### **REMARKS**

Appl. No. 10/628,191  
Amdt. Dated August 29, 2005  
Reply to Office Action of April 28, 2005

3/8

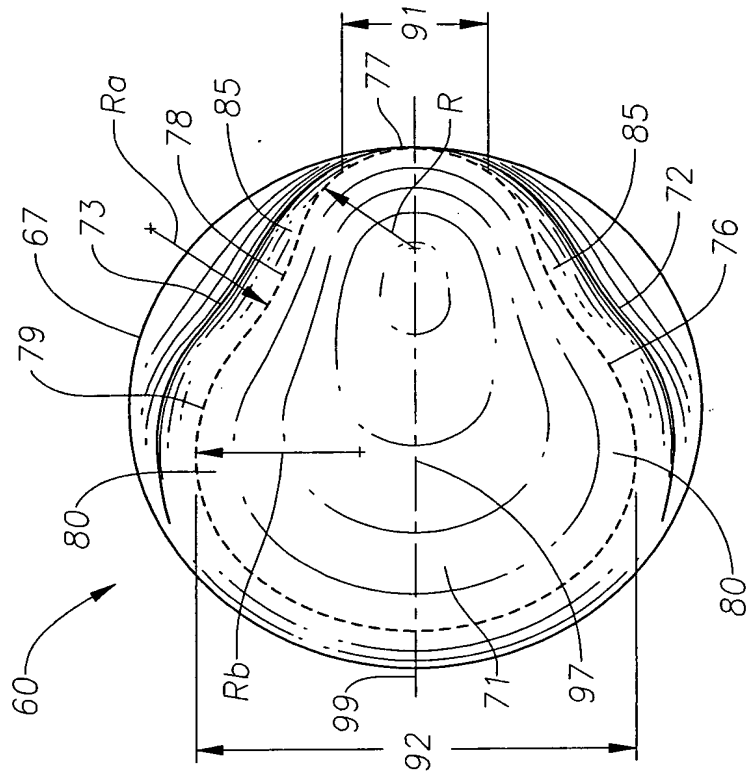
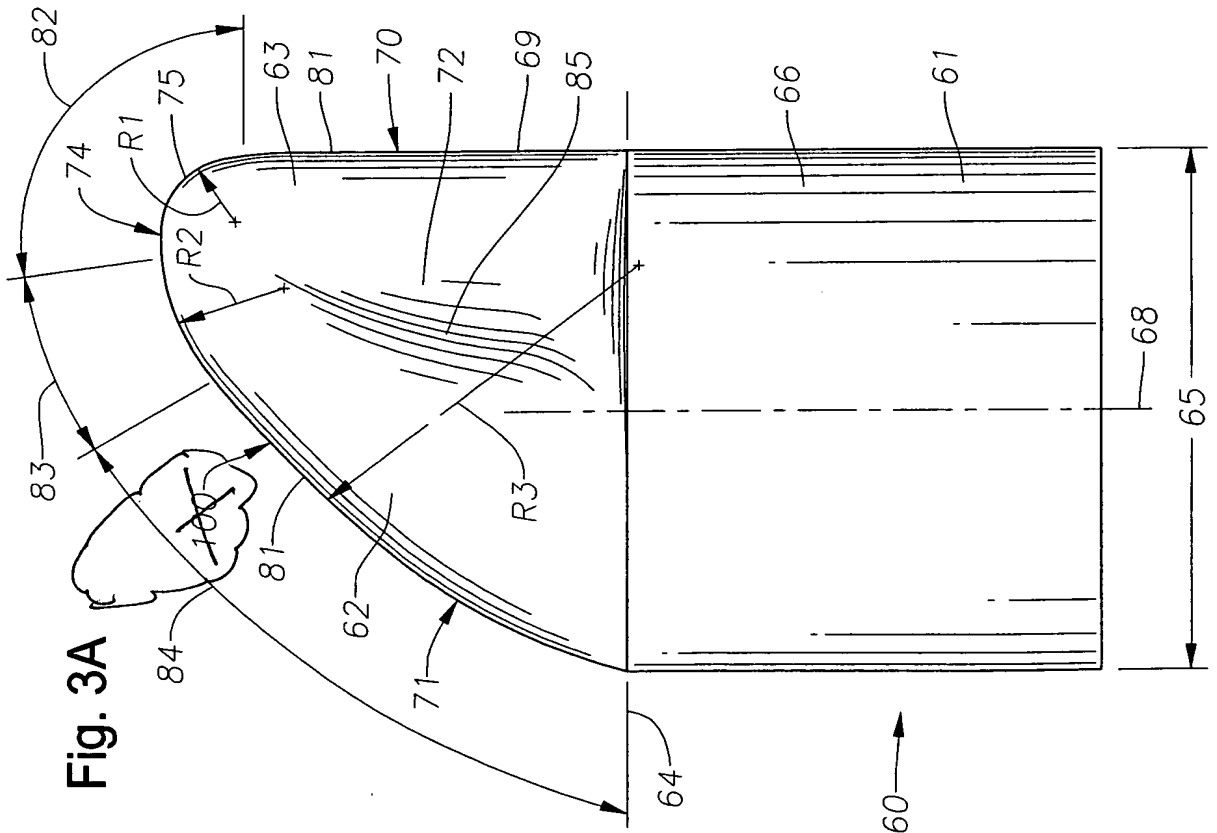
The Examiner objected to the drawings as failing to include reference numerals mentioned in the specification and for including reference numerals not mentioned in the

Replacement sheets of drawings 2 of 8, 3 of 8, 4 of 8, 6 of 8, and 8 of 8 are enclosed, reflecting amendments to drawing Figures 2, 3A, 4A, 5A, 6 and 7. These replacement sheets have been amended to include reference numerals 57a, 181 and 281, which the Examiner identified as included in the specification but missing from the drawings. No new matter has been added by these amendments. Likewise, the drawings have been amended to delete reference numerals 100 and 320 which the Examiner noted were not used in the specification. However, designations 193 and E have not been deleted from the drawings as they were included in the specification. Reference numeral 193 was described in paragraph 50, page 15 and identifier E was described in paragraph 56, page 17 of the original specification. For the Examiner's convenience, changes to these drawings are reflected on the additional set of attached replacement pages, with the changes shown in red ink.

specification. As mentioned above, submitted herewith are replacement drawings correcting the drawings to add, and delete, as appropriate, the reference numerals identified by the Examiner. No new matter has been added. Applicant believes that these drawings fully comply with 37 C.F.R. § 1.84(p)(5).
